**For: O' Flynn Construction**

Residential Development, Maglin,  
Ballincollig, Cork

Quality Audit Report  
**September 2025**

**Figure 5.8 Lack of tactile paving at crossing point**

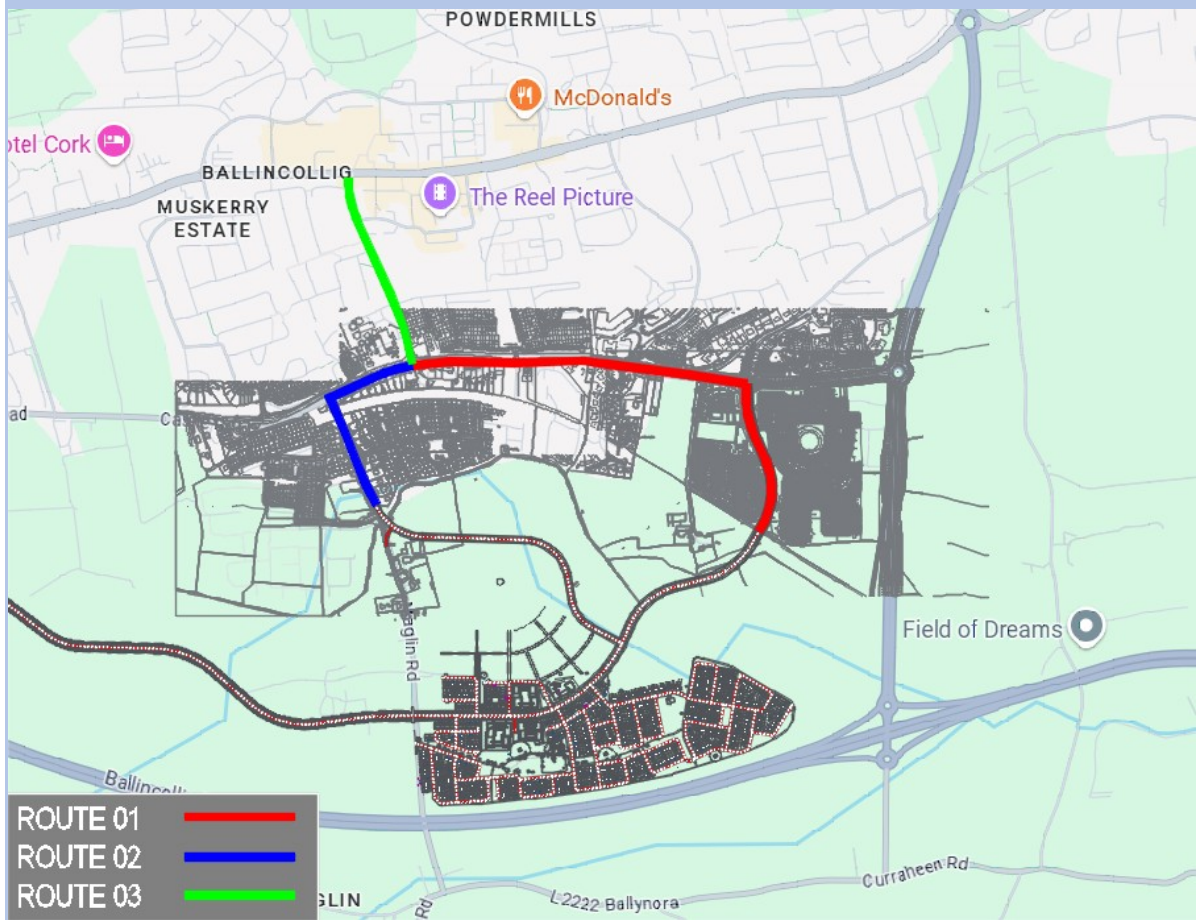
**Issue:** No tactile paving at access junction of Cranford Pines Housing Estate. Failure to provide tactile paving can lead to vulnerable users, particularly the visually impaired, encroaching onto the roadway unbeknownst to them. This could lead to collisions between vehicles and pedestrians.

**Recommendation:** Include tactile paving at both sides of crossing point.

Route 03 begins at the junction of Kilmney Road & Station Road. The route runs north along Station Road until it's intersection with Main Street.

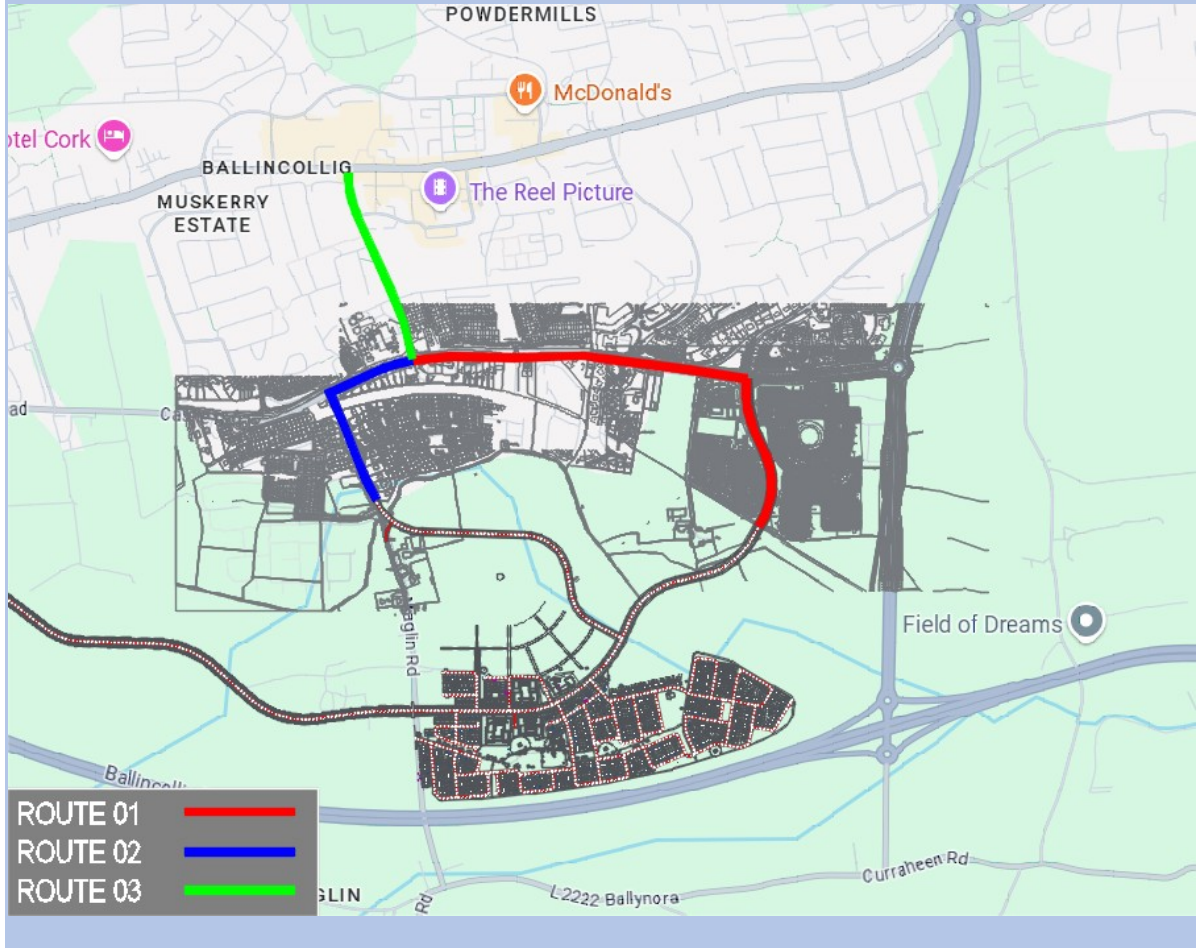
**Issue:** The access junction of The Maltings Housing Estate does not include pedestrian suitable crossing facilities. A lack of appropriate crossing facilities can lead to vulnerable pedestrians coming into conflict with vehicles.

**Recommendation:** Provide a suitable crossing point including tactile paving and dropped kerbs.
